Subject:
 RE: Agro Liquid - 70517

I reviewed the application per the portal on 5/1/2025. I approved the 'connection with county roadway' portion of the permit and entered a note.

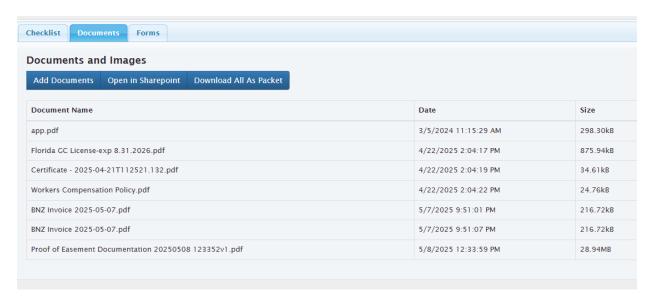
1. Please relocate the 3000-gallon septic tank from the proposed county right of way and place it on private property. Sheet C-208
